REV.	DATE	DCN #	DRAWING TREE #
v1	11 OCT 2019	-	-
v6	17 JAN 2020	-	-
v7	13 APR 2020	E2000209-x0	-

SYSTEM		SUB-SYSTEM		DESIGNER	C.ROMEL	SIZE	DWG. NO.	REV.
A+		VE		DRAFTER	D.BROWN	11 OCT 2019	D1900456	v7
MATERIAL		FINISH		CHECKER	SEE DCC	SEE DCC	SCALE: 1:105	PROJECTION:
N/A		N/A μinch		APPROVAL	SEE DCC	SEE DCC	SHEET 1 OF 1

A+, FC, BEAM TUBE LAYOUT

FC-C (SECTION I)

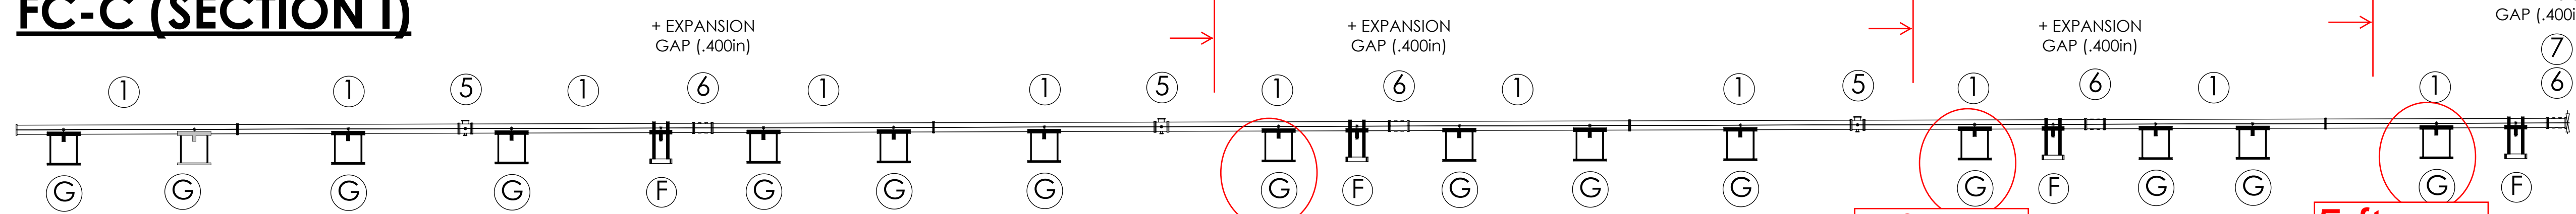
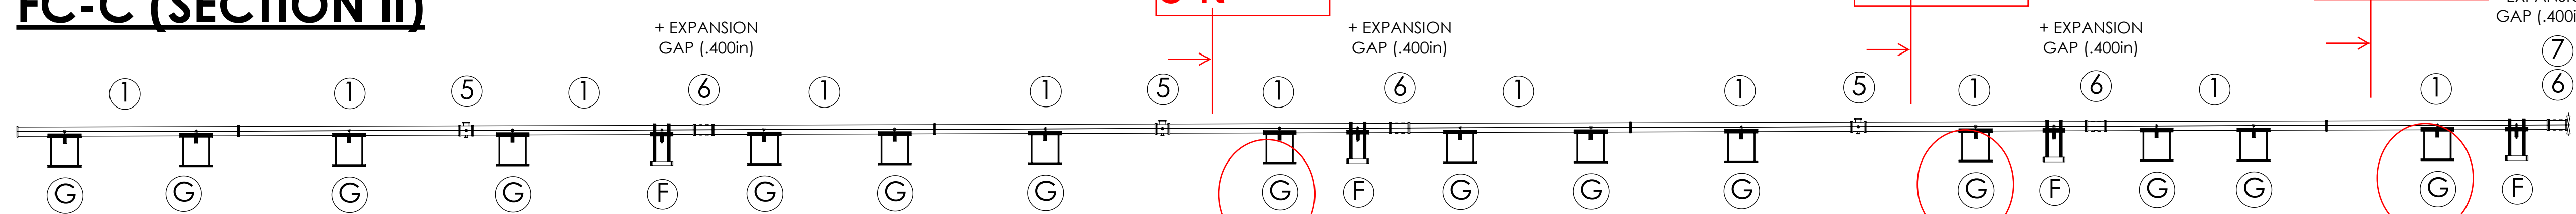
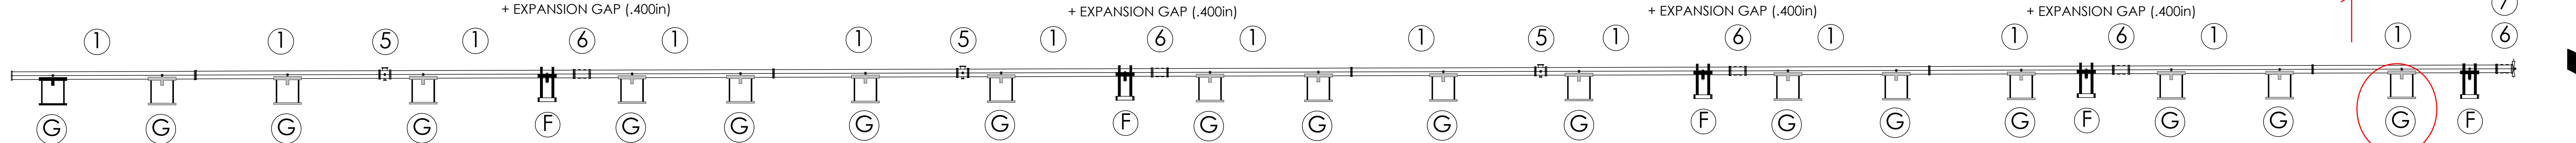
error recurring throughout FC-C layout regarding interpretation of T200002 (current is -v2) section 5.1.5 - final bullet point applies, with 5 ft spacing from CF joint
